State of Ohio Environmental Protection Agency

July 13, 2010

**Re: Construction Storm Water Inspection at Albany Landings Phase 1, 2 & 3,
Permit Number 4GC02210*AG**

Figure 1: Sediment pond lacks a riser.

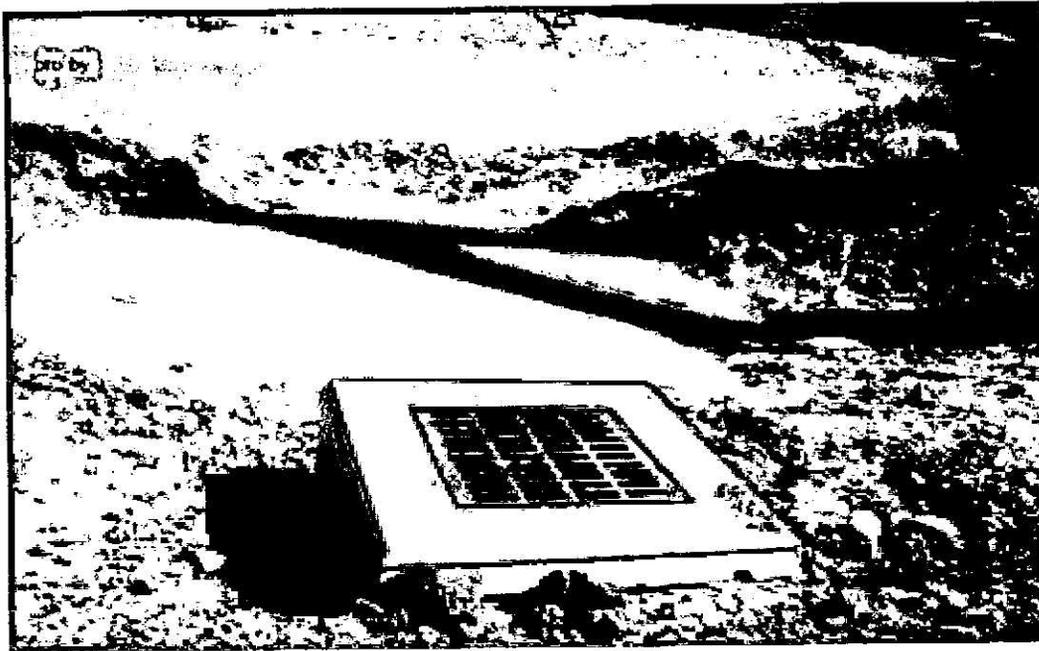
- All barren areas on the southern and eastern end of the project must be protected with perimeter silt fence.
- It has been noted that the sediment pond does not incorporate a sediment control structure such as a temporary riser. All sediment ponds must be modified to address sediment control. Corrective measures are expected within three days from receipt of this letter (figure 1).
